RECEIPT DATE: 8-13-18 **ONSITE SEWAGE DISPOSAL SYSTEM** P 63979

PROPERTY ADDRESS: 12333 Point Ridge Drive

SUBDIVISION: Regan Property LOT: 10 TAX ID: _____

PLAT TRANSMITTAL SHEET

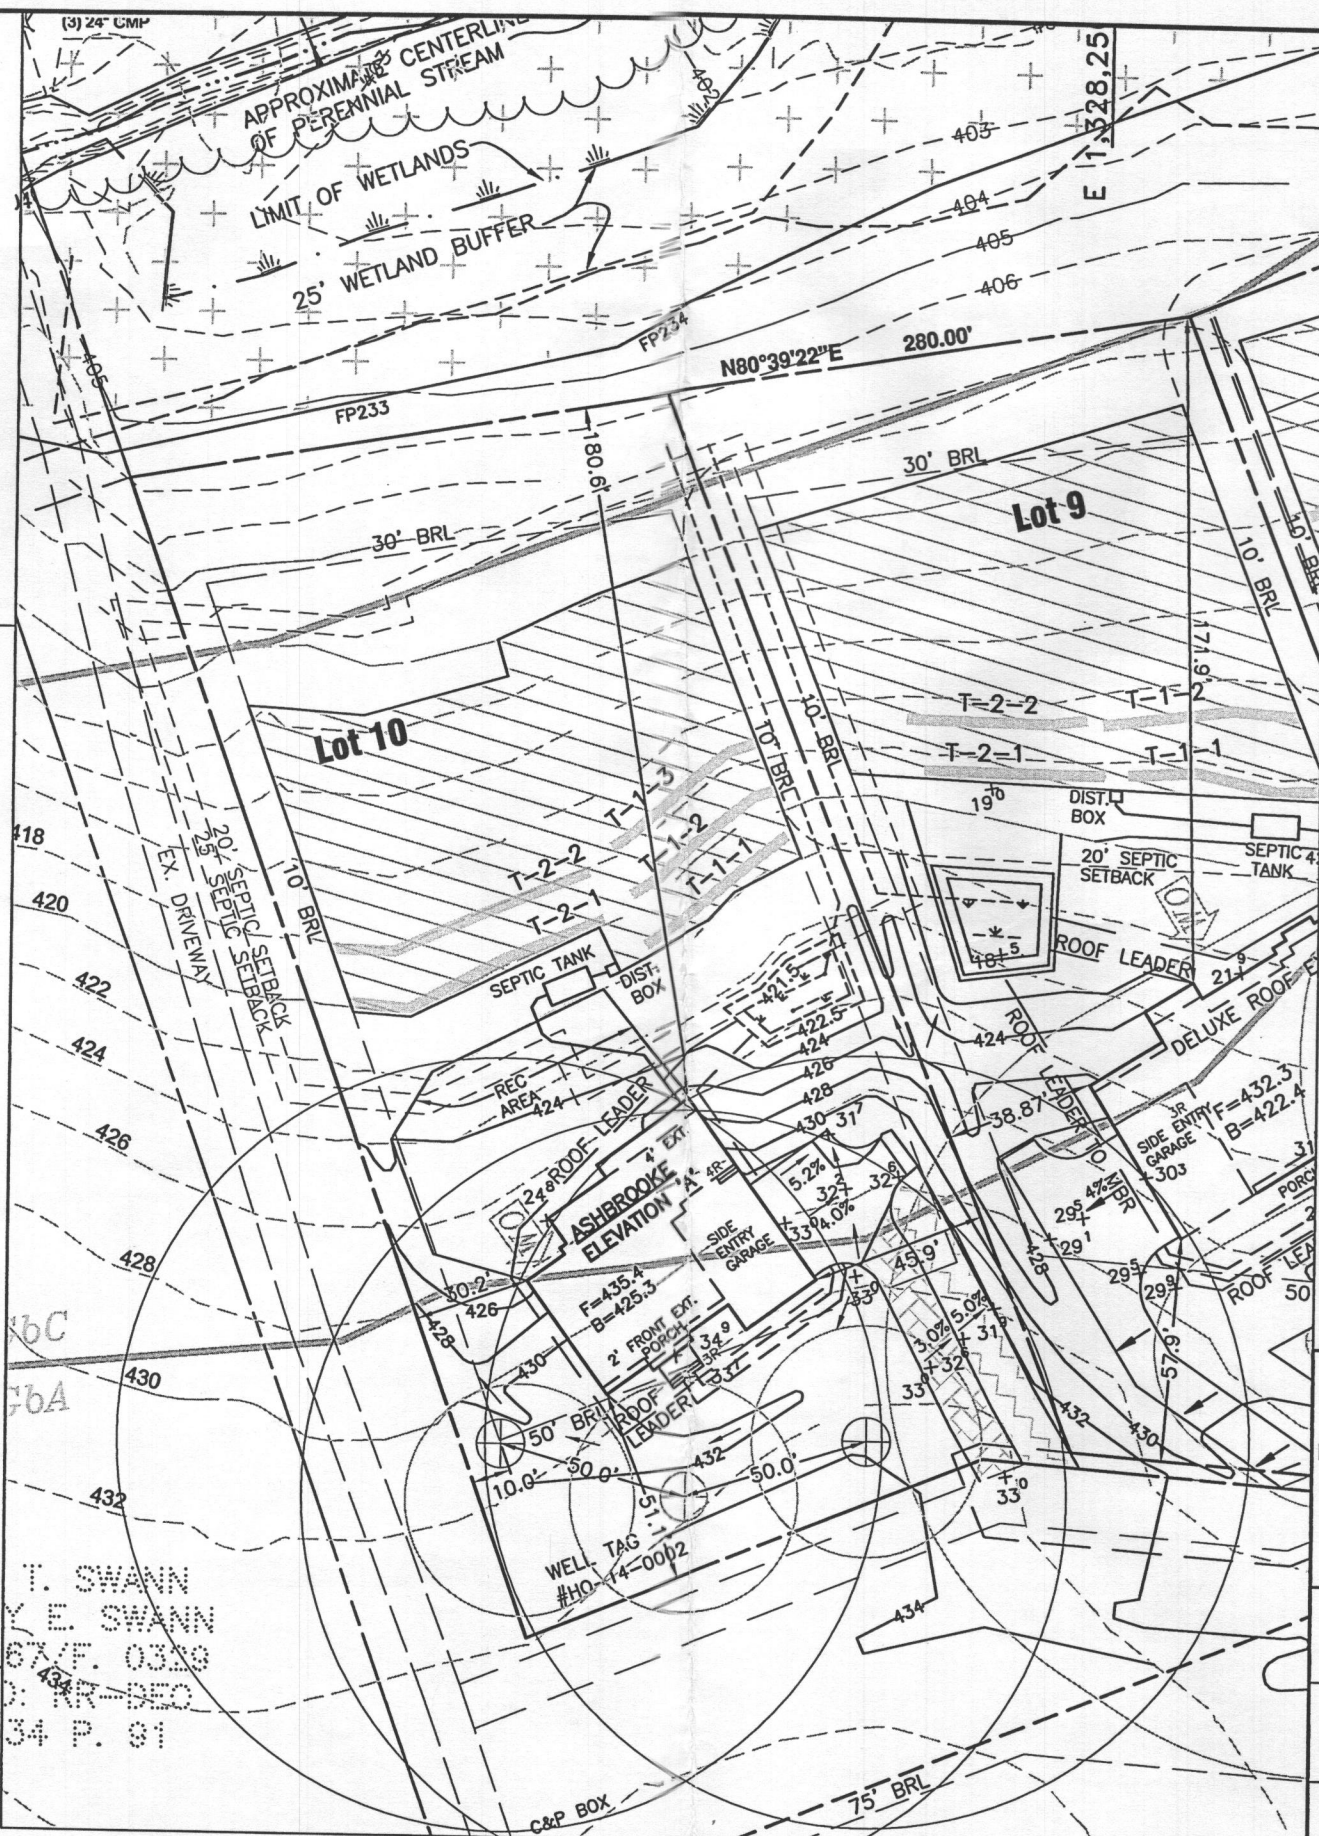
- Septic tank shown is less than
25' from ~~bed retention pond~~ ^{rain garden}.

they don't need to show tank on PC,
~~if~~ they could white it out ~~and~~ and show proper
location on OSDS plan

Lot 10 Septic
SCALE: 1"=50' HORIZ., 1"=5' VERT.

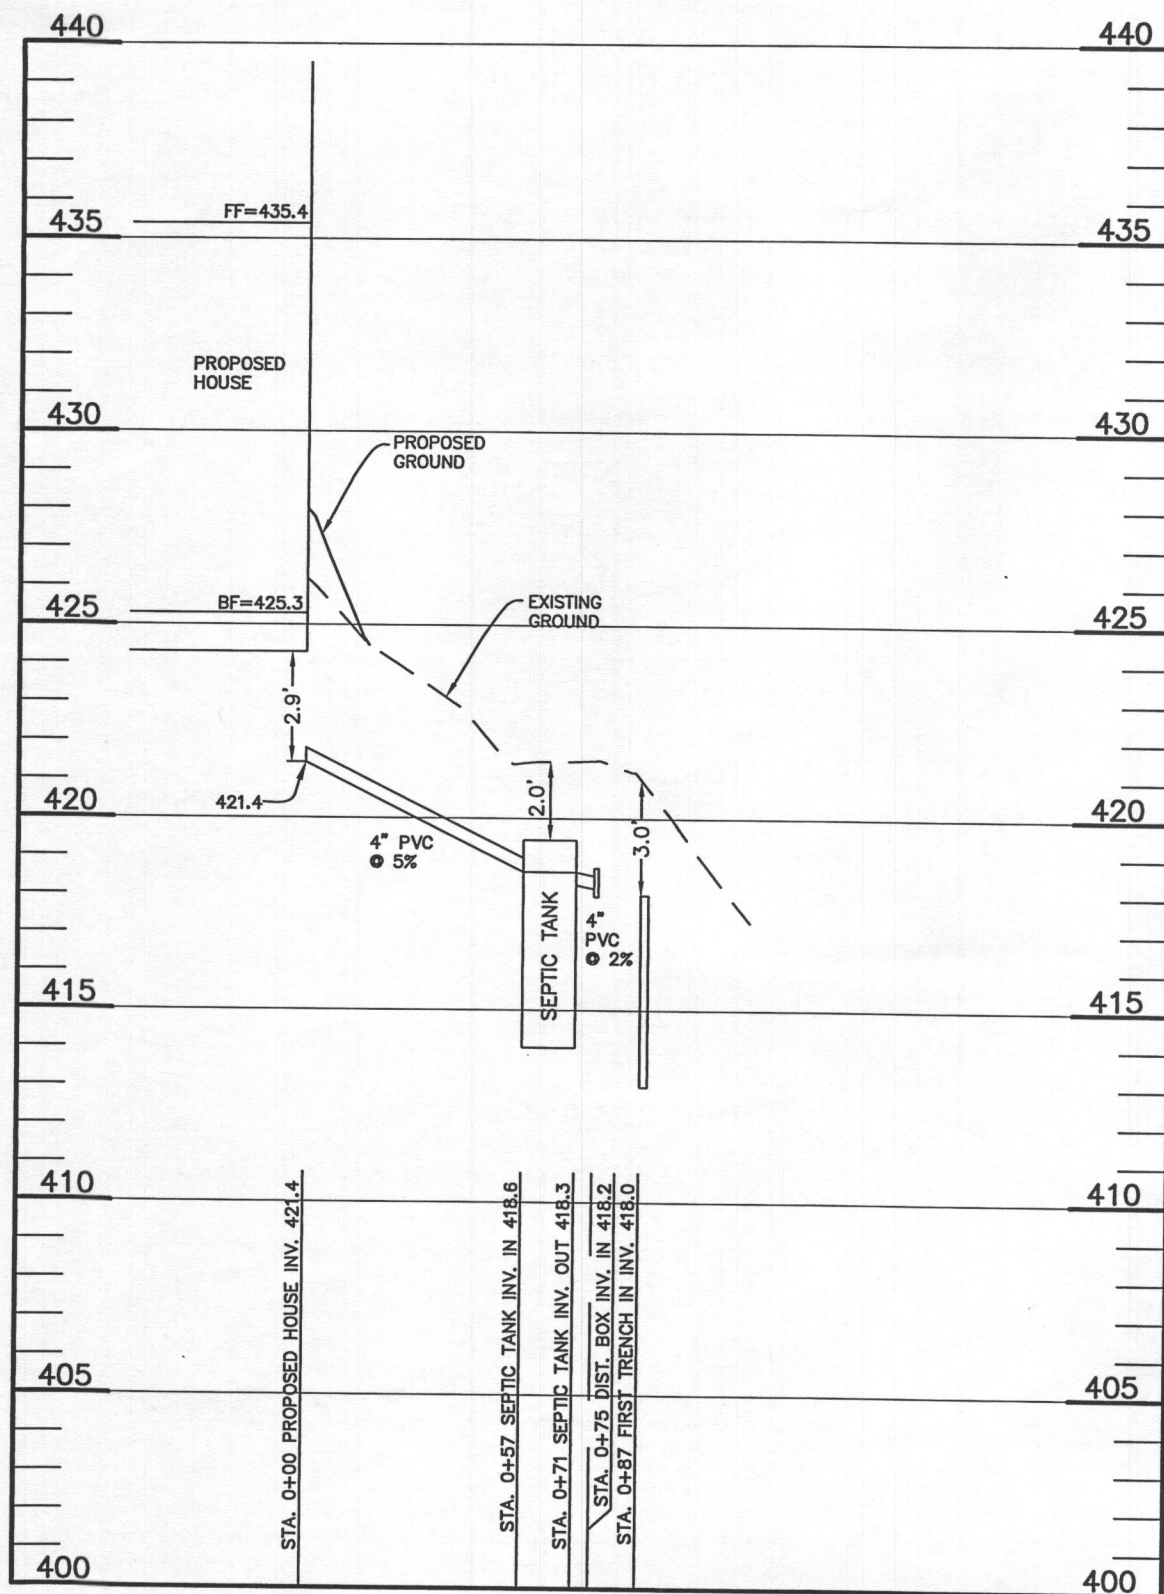
No. Because the septic tank is less than 25 feet away from the rain garden. And we need to adjust the trenches to 71 feet. (2 trenches for the initial)

1. I received your revision and I am sending it up for signature. However you must send a revised OSDS plan. Also lets try to utilized this area better. Please separate the initial system and the first repair into 2 trenches on contour. As shown in the diagram below:

REMARKS: ① Moved tank to be at least 25' from Microbio retention. Reconfigured trenches as discussed in email to you.

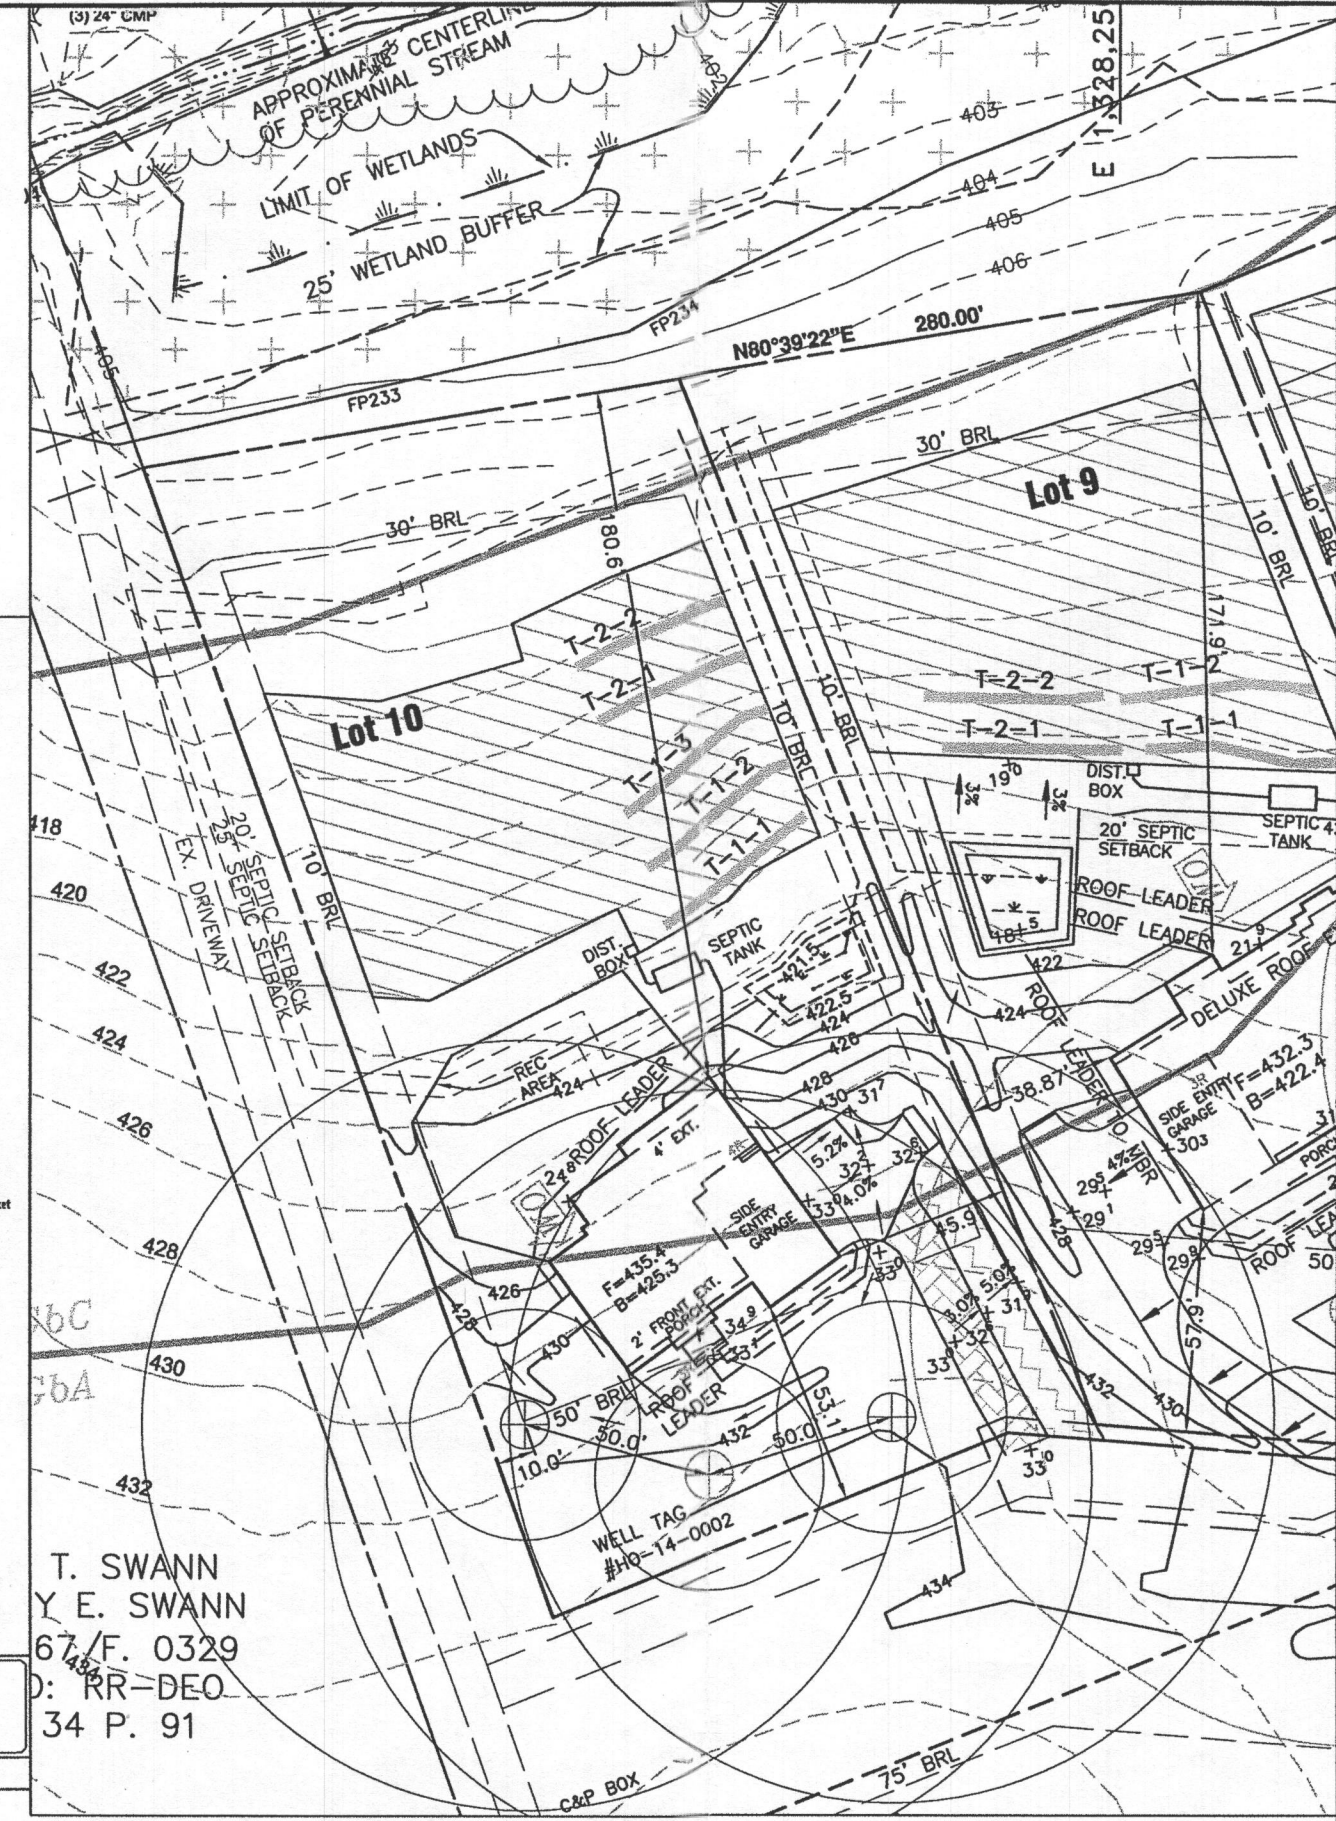
1. The septic tank shown is less than 25 feet away from the rain garden.
2. You don't need to show the tank on the PC, however it must be shown on the OSDS.
